Re: S/D 94-19 - EBERSOLE ADDITION (Final Plat)

STAFF REPORT

CASE NUMBER: S/D 94-19 EBERSOLE ADDITION

**FINAL PLAT
FOR
EBERSOLE ADDITION
AN ADDITION TO WICHITA, SEDGWICK COUNTY, KANSAS**

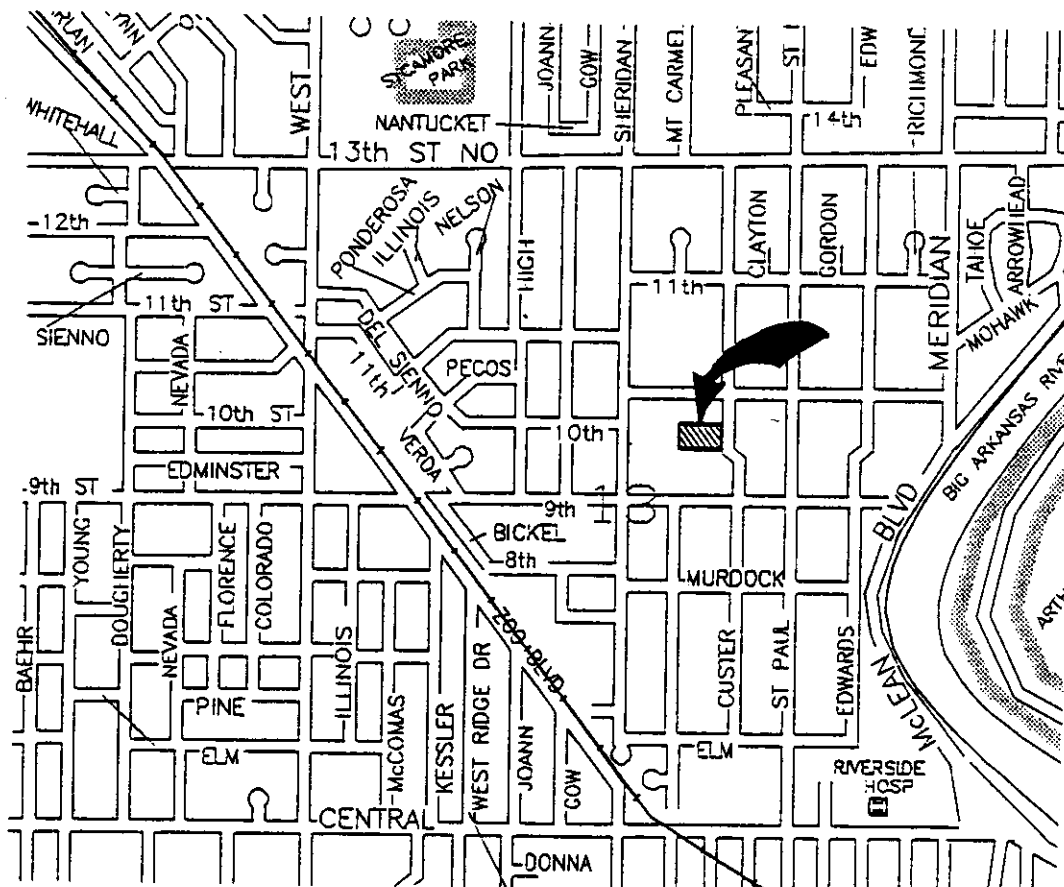
- L. Perimeter closure computations shall be submitted with the final plat tracing. Section 5-101(c).
- M. Recording of the plat within 30 days after approval by the City Council.
- N. As requested by the Fire Department, on the final plat tracing the "T" portion of the turnaround shall be 92 feet in length north to south. That is, the plat shall dedicate additional right-of-way for indicated section of this cul-de-sac street.

- A. The applicant shall guarantee the extension of City water to serve the lots being platted.
- B. The applicant shall guarantee the paving of the narrow public streets to the 29-foot paving standard.

- D. On the final plat tracing, the setback on Lots 2 & 3 to Custer Court should be labeled as building rather than garage setbacks. For Lots 1 & 4, a note should be placed on the face of the plat explaining that the "garage" setback to Custer Court does not apply to main structures or other uses but only garages. That is, the house is restricted by Zoning or other platted conditions such as the 15' street-drainage-utility easements.

- E. The applicant shall submit a covenant which provides for four (4) off-street parking spaces per dwelling unit on each lot which abuts a 32-foot street. The covenant shall inventory the affected lots by lot and block number and shall state that the covenant runs with the land and is binding on future owners and assigns. It should be noted that this requirement further highlights the need to assure adequate driveway lengths are provided for such off-street parking.

- F. Since this plat proposes the platting of narrow street right-of-way with adjacent "15-foot street, drainage and utility easements," a restrictive covenant shall be submitted which calls out restrictions for lot-owner use of these easements. Retaining walls and change of grade shall be prohibited within these easements as well as fences, earth berms and mass plantings. Any plantings within the easement shall be reviewed by the City Forestry Division prior to installation.

- G. On the final plat tracing, the 3rd line of the platdor's text should be revised to note that the site is being platted into lots.
- H. The applicant is reminded that an updated platting binder must be submitted for this site and that this plat will be subject to a review of this binder and will be subject to any applicable conditions of such a review.
